Subject: Rice Solar Energy Project (09-AFC-10)
Response to CEC Workshop Query 12

Response to CEC Staff Workshop Query 12

Rice Solar Energy Project

Elimination of the Stormwater Detention Basin

**PRELIMINARY
NOT FOR CONSTRUCTION**

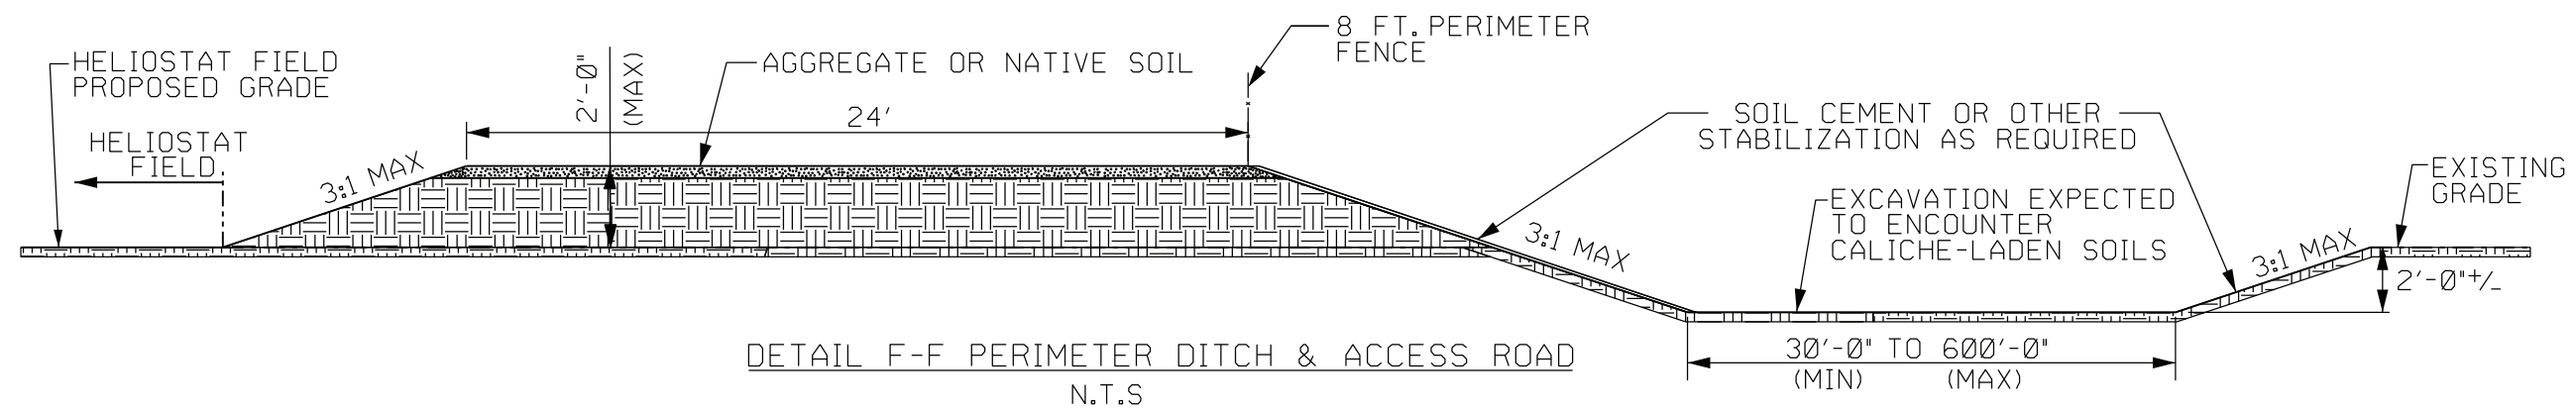
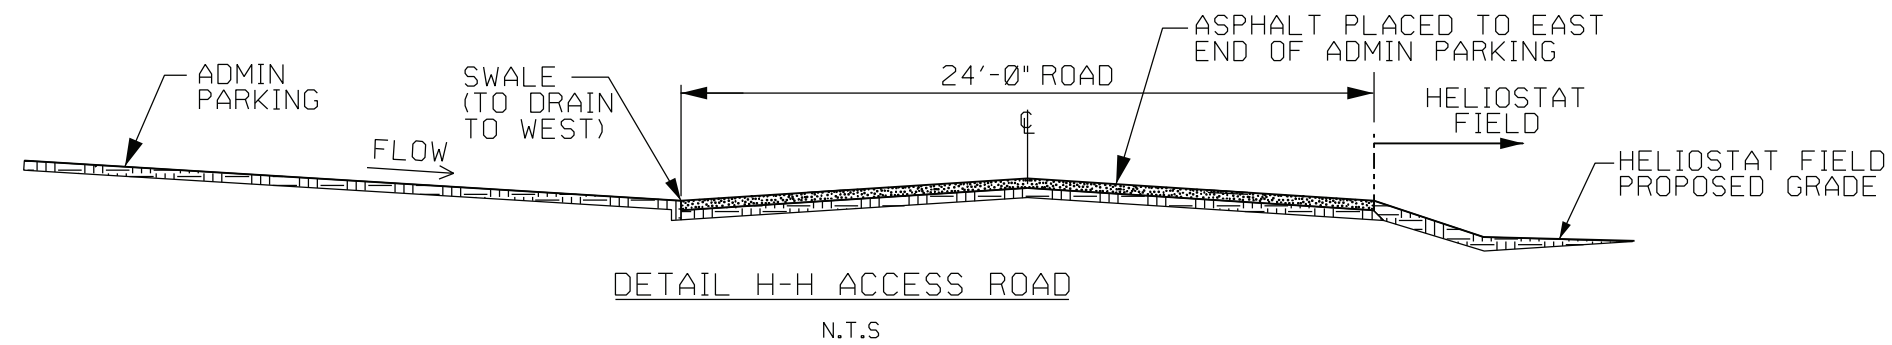
WSQ 12 Please provide a revised General Arrangement and associated drawings that depict the elimination of the stormwater detention pond, and provide a discussion of whether this is a feasible design.

- AFC Figure 2.2-1, Overall Site Plan and Conceptual General Arrangement (Figure WSQ12-1)
- Figure DR68-1a, Conceptual Grading and Drainage Plan (sheet 4, Figure WSQ12-2a)
- Figure DR68-1b, Conceptual Grading and Drainage Plan Cross Sections (sheet 5, Figure WSQ12-2b)
- Figure DR68-1c, Conceptual Grading and Drainage Plan Cross Sections (sheet 6, Figure WSQ12-2c)

It would be feasible to eliminate the stormwater detention basin and construct the southern perimeter loop road at grade. As shown on the drawings, the heliostat perimeter road would be constructed at grade under this alternative, and the detention pond would be eliminated. Under this alternative, onsite stormwater flow would not be directed to a detention basin and the onsite storm flows would tend to follow their current drainage pathways across the heliostat field loop road offsite to the south. Using this design, increases in stormwater flows would not be mitigated by detention and slow release, as with the detention pond design.
